Below updates / changes apply to the tbone aviation™ headset User Manual – 258260 HO rev. A.

*RED Marker = Right Earpiece  
(Right ear)*

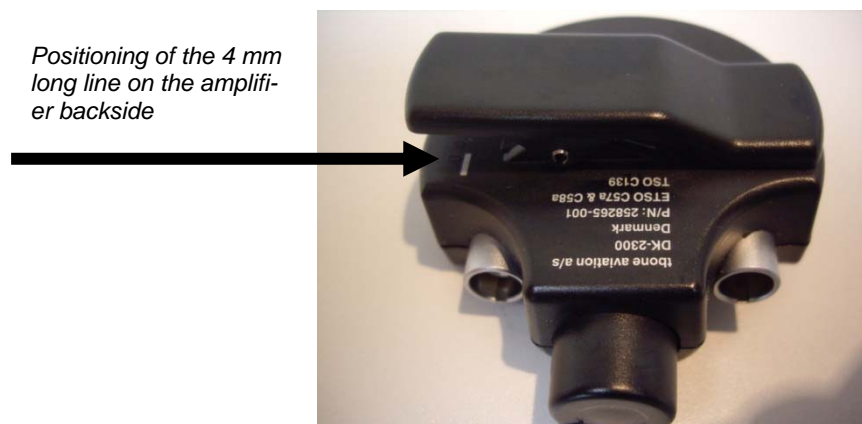
**Page B3**      *“Place the earpieces in front of you, holding the right earpiece in your right hand and the left earpiece in your left hand, and .....”*

**Changed to**

*“Place the earpieces in front of you, holding the right earpiece (marked with a RED marker on the cable) in your right hand and the left earpiece in your left hand, and .....”*

**Page B5**     ***“Adjusting the Headset”***

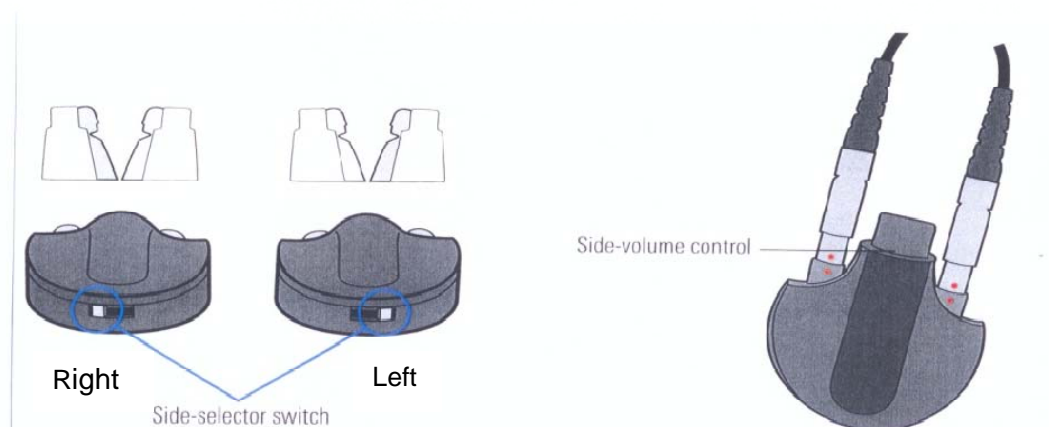
*“Flip the side-selector switch on the amplifier to reduce the volume in the ear closest to you fellow pilot. You may turn the volume further down, or turn it off completely by the volume control on top of the amplifier”*

**Changed to**

The picture on page B5 should be change to above.

“Flip the side-selector switch on the amplifier to reduce the volume in the ear closest to you fellow pilot. If seated in the left seat, flip the side-selector switch to the right, and vice versa. You may turn the volume further down, or turn it off completely by the volume control on top of the amplifier”

### **XLR Connector Configuration**

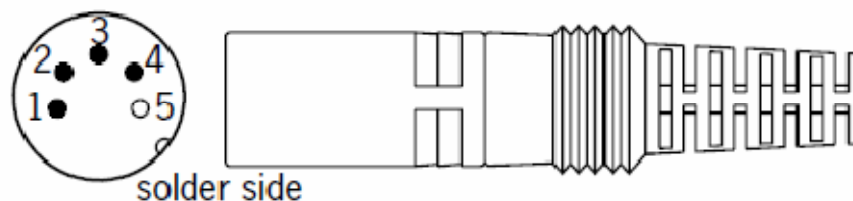
**Page C5** An additional page C5-1, showing XLR connector configuration, shall be inserted (currently only JACK connection configuration is showed in the User Manual – C5).

Connector (see section 5.1)	Wire color	Signal
1	Green	Loudspeaker high (LS+)
2	Blue	Loudspeaker low (LS-)
3	Red	Microphone high (MIC+)
4	Brown	Microphone low (MIC-)
5	<i>(Reserved for future use)</i>	<i>(Reserved for future use)</i>
Back-shield*	<i>Shield from MIC</i>	<i>MIC Shield</i>

**\* Shield from MIC soldered on Back-shield of plug!**
